# Addendum

Project: West Toronto Community Health Services  
Community Health Centre

Addendum No.: 03

## Architectural Addendum No. A03

7 PERIMETER DETAIL @ WINDOWS  
1 : 10

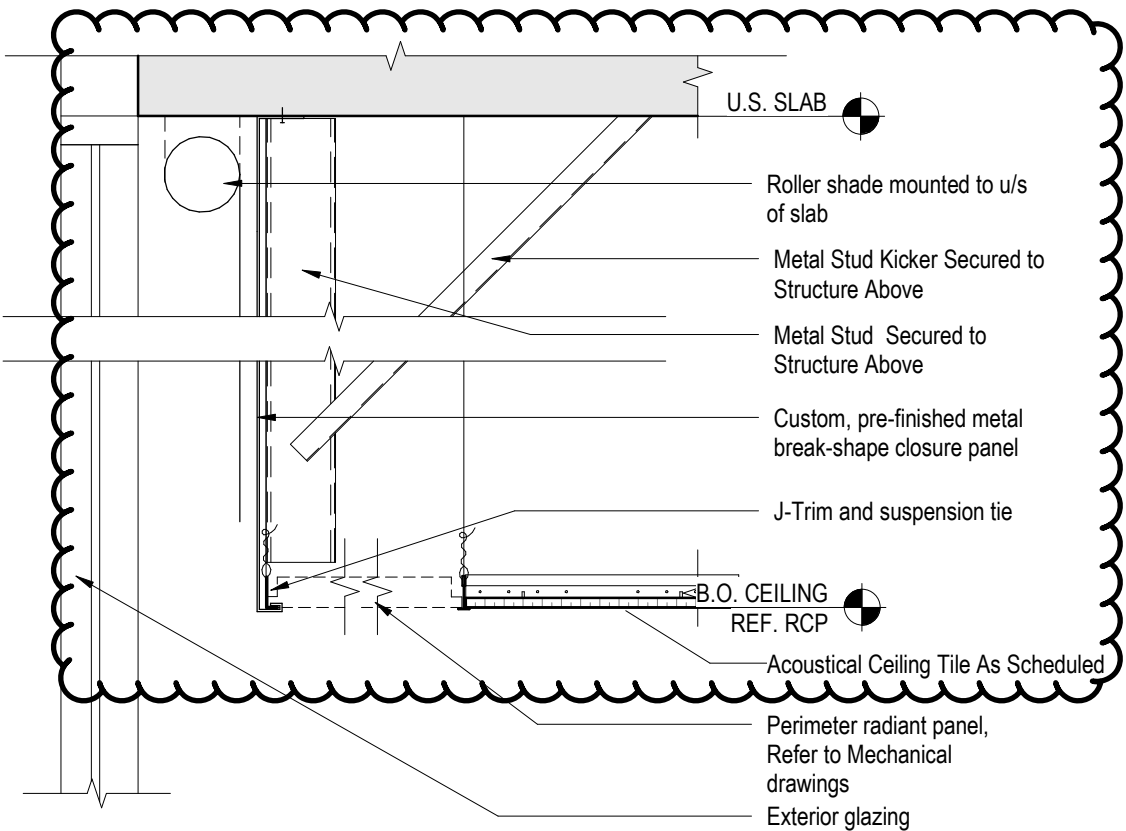
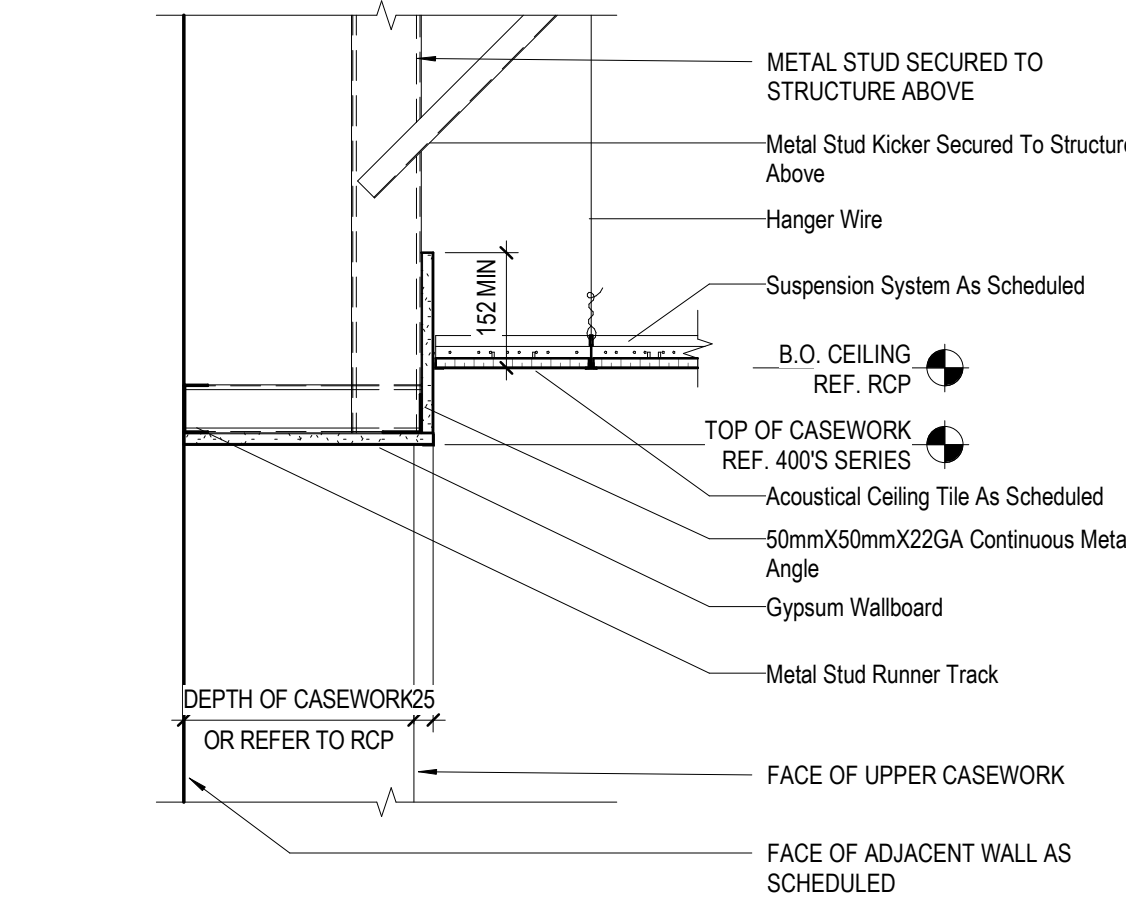
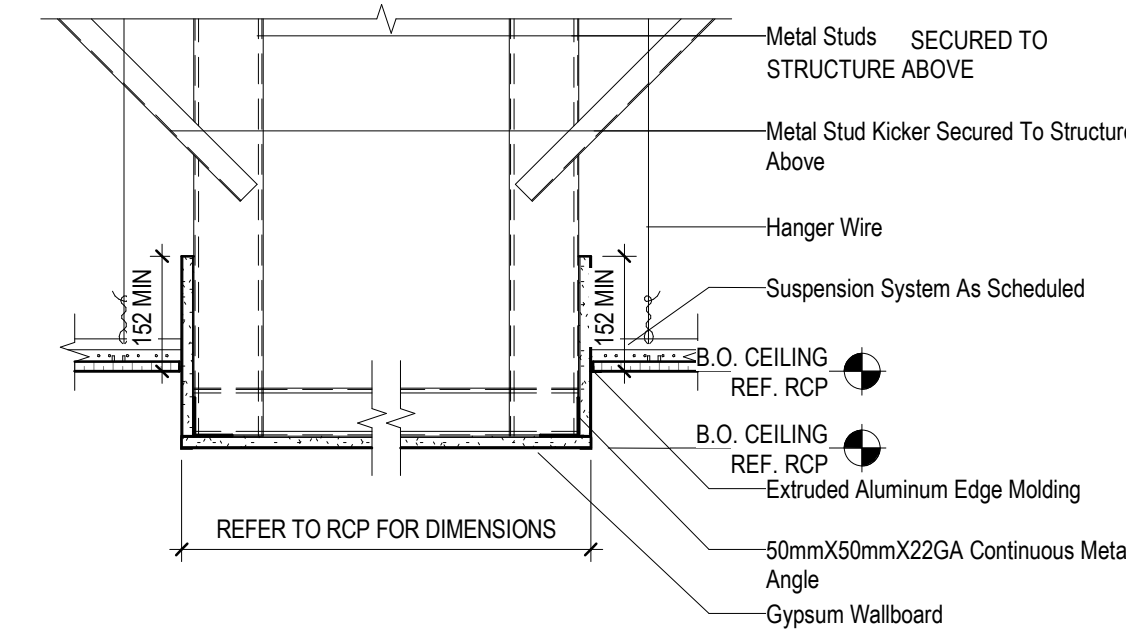
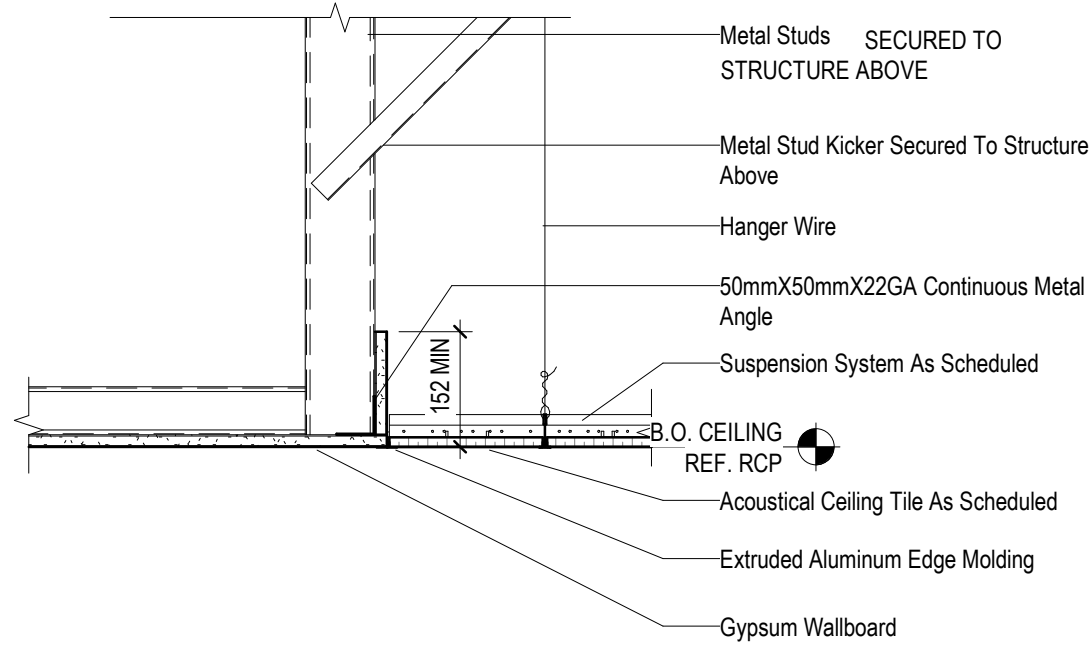
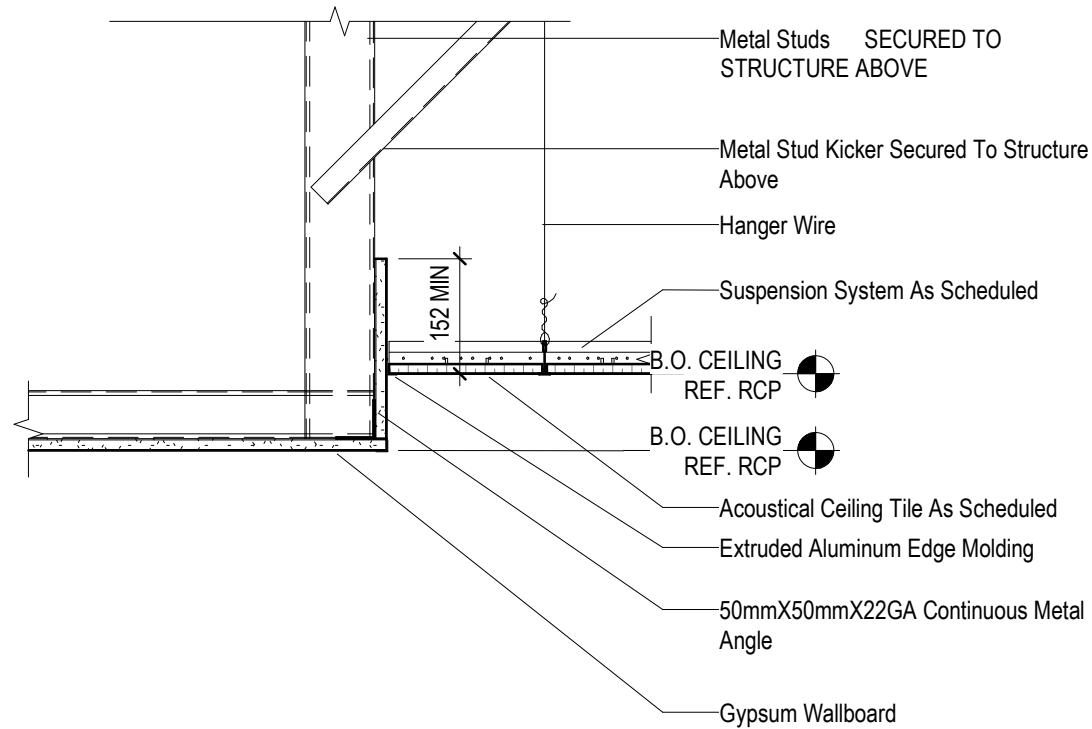
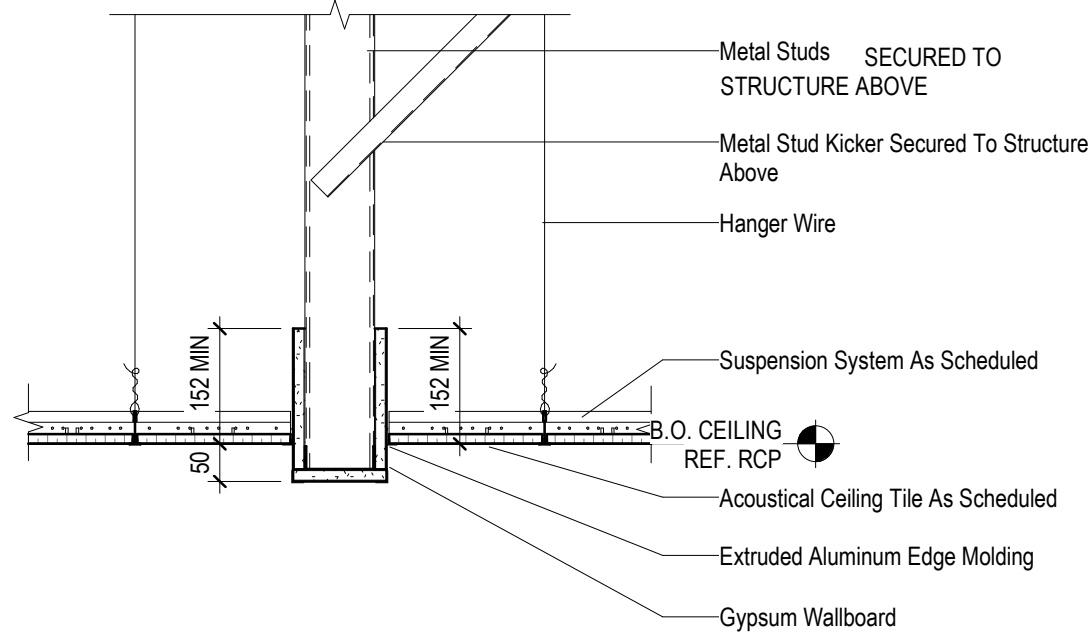
*Per detail 7/A502 the custom prefinished metal fascia is specified as 24ga. Please advise if the perimeter radiant panels can be supported by this.*

Refer to Drawing A-502 INTERIOR DETAILS CEILINGS reissued herewith, dated 2024.10.17.
